NOTICE OF PREPARATION MATERIALS

Subject: Notice of Preparation of a Draft Program Environmental Impact Report

Project Title and Number: City of Carlsbad Drainage Master Plan Update Program EIR (Project No. 04-02)

Figure 2
Drainage Basins

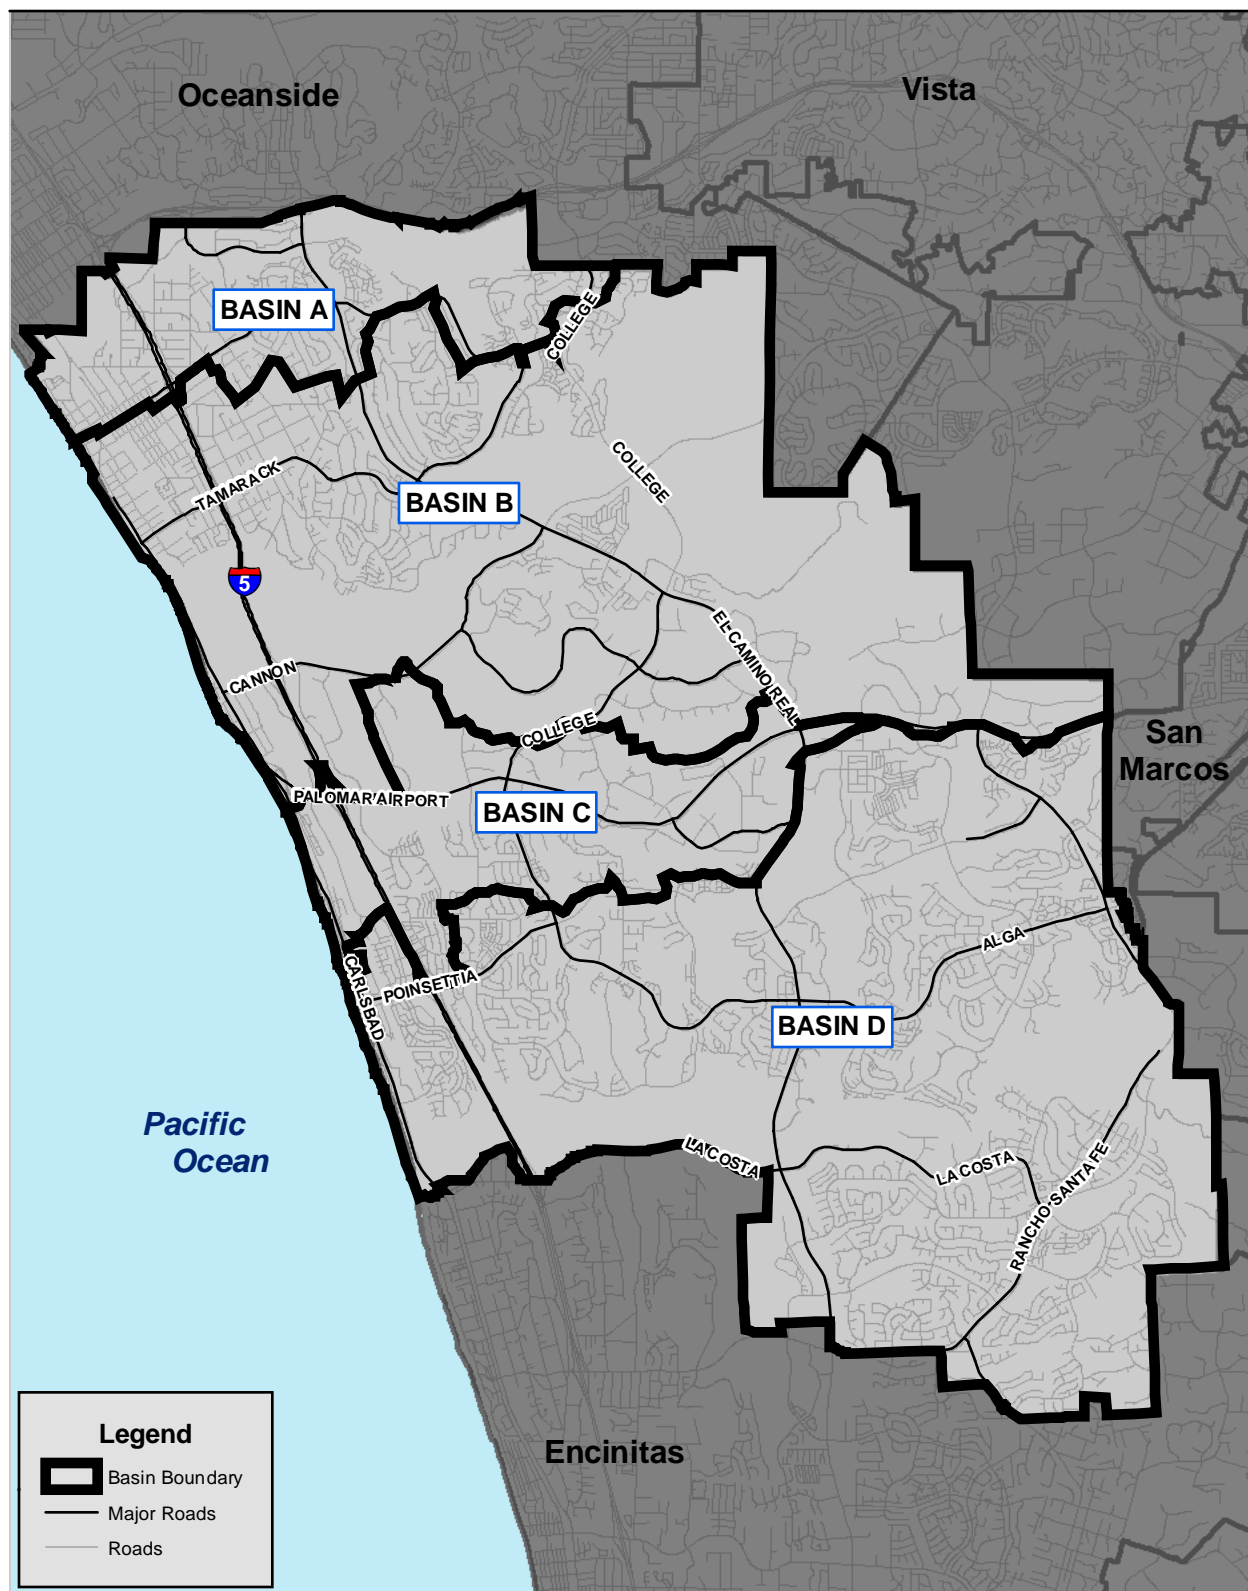
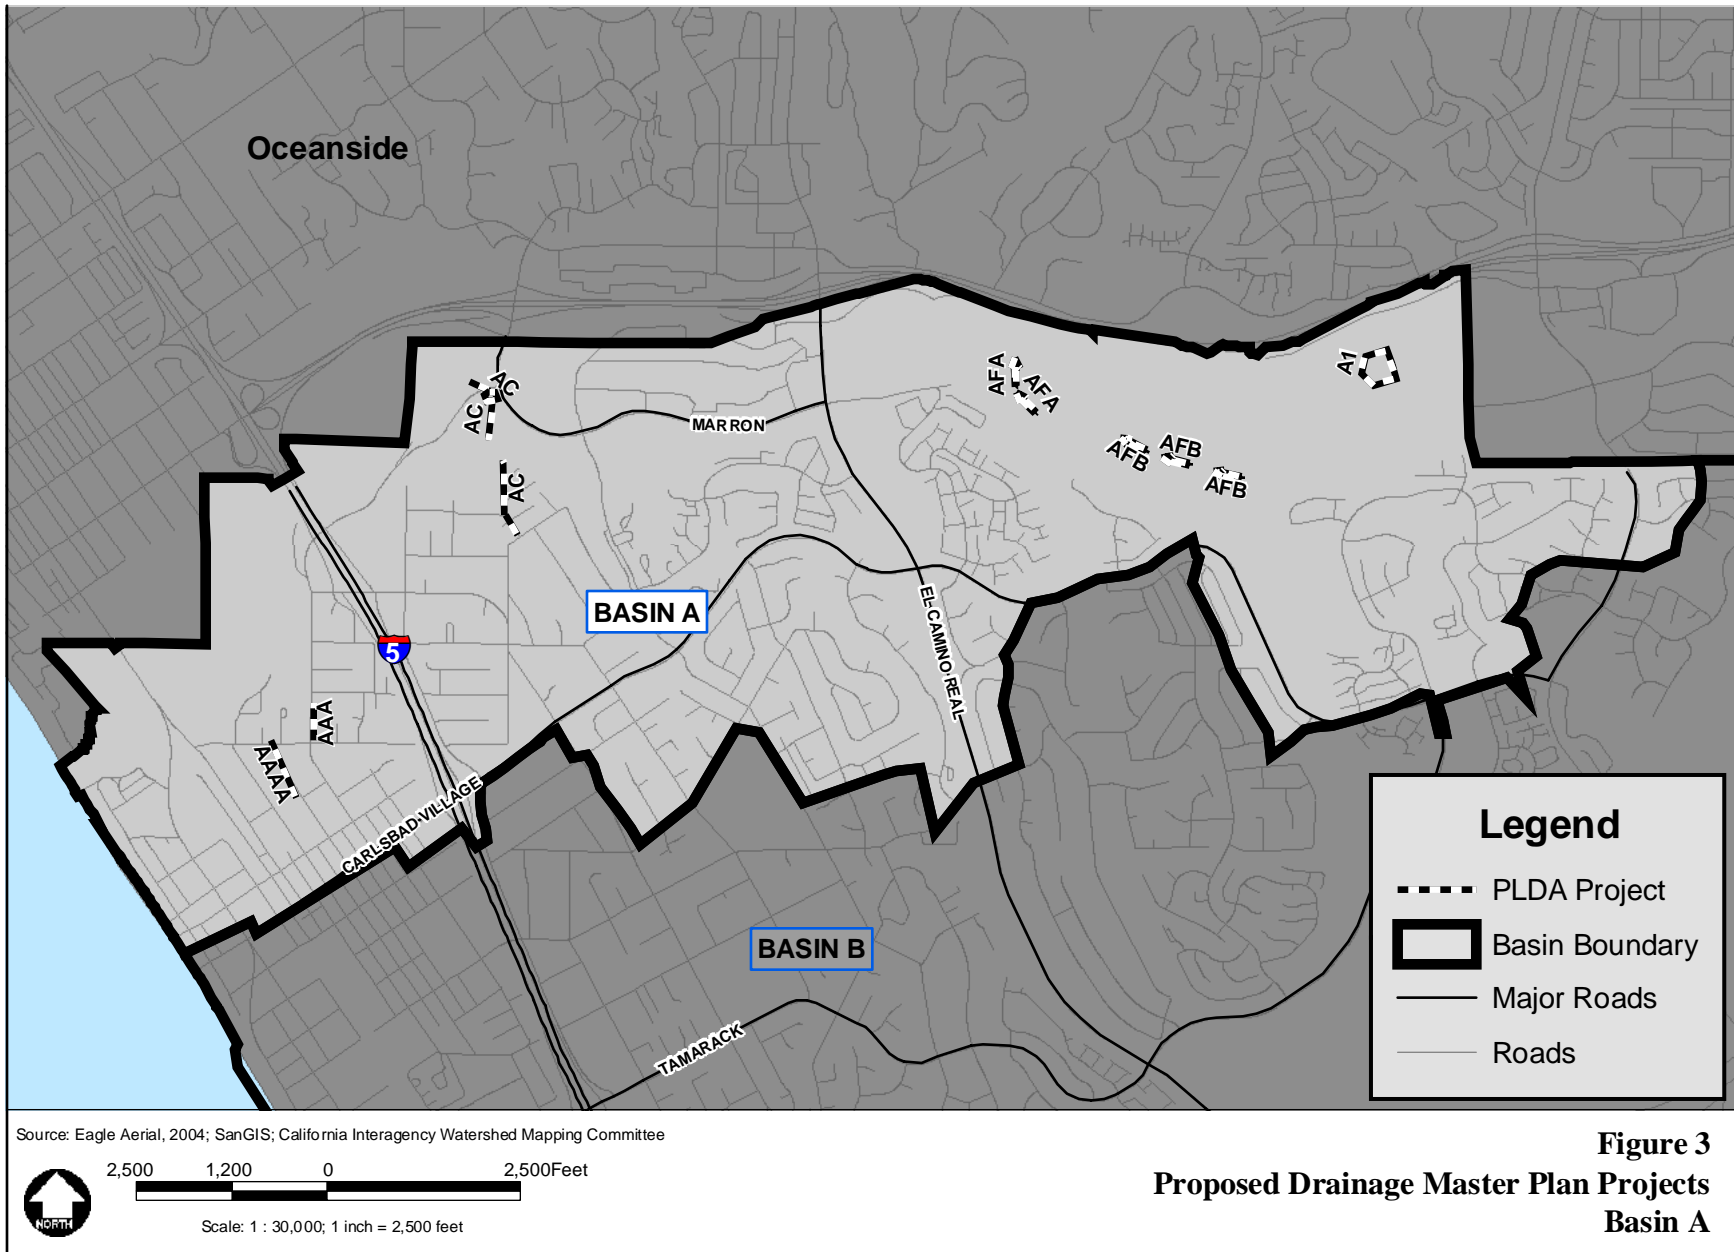
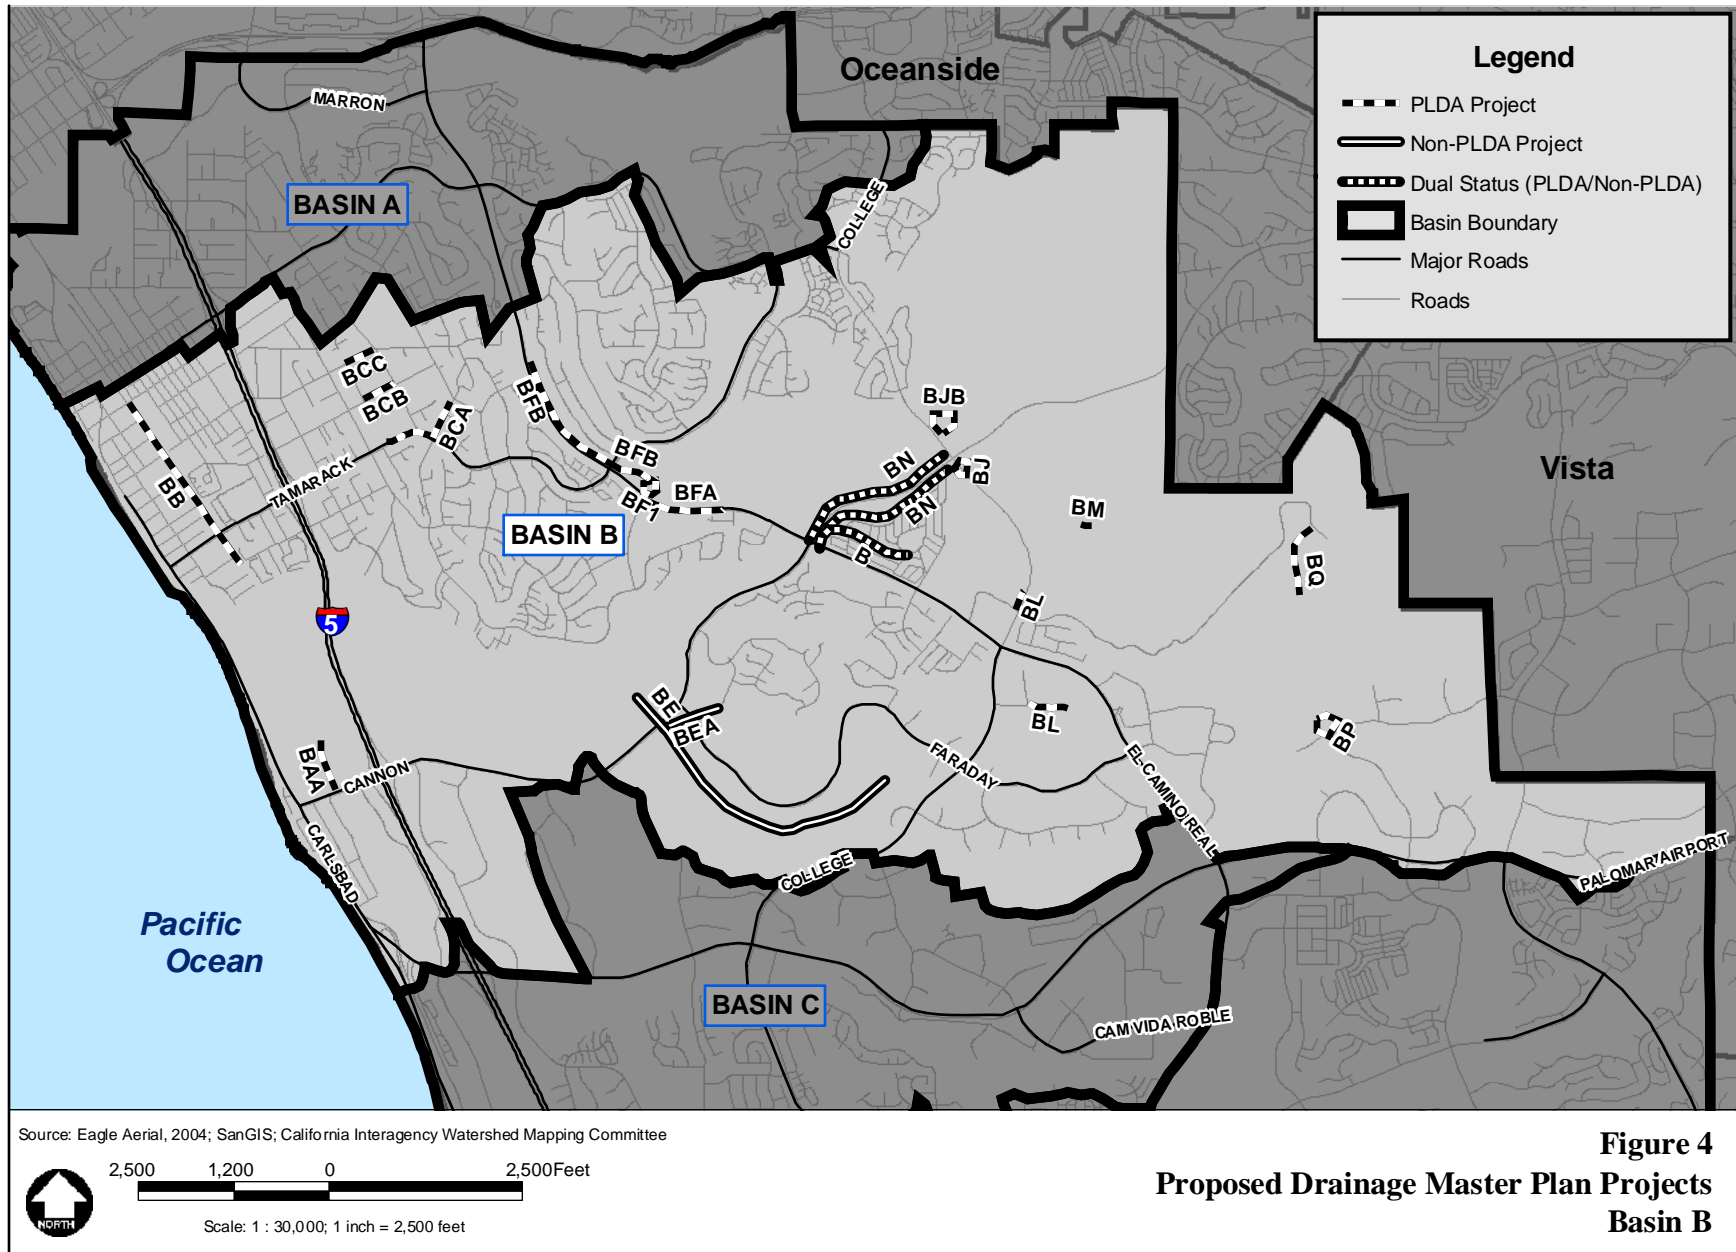
The project should differentiate between the City limits (Plan limits) and the actual "Basin Limit" as shown on Figures 2, 3, 4, and 6. The actual drainage "basin limit" extends easterly beyond the Master Plan limits (i.e.: the City limits). Also, the City of Carlsbad should coordinate drainage improvement projects adjacent to Interstate 5 (I-5) described in the Master Plan with the Caltrans I-5 North Coast Widening Project in case there are conflicts or beneficial opportunities. Caltrans is currently developing the I-5 North Coast project in order to increase capacity on the I-5 corridor in the vicinity of this proposed project.
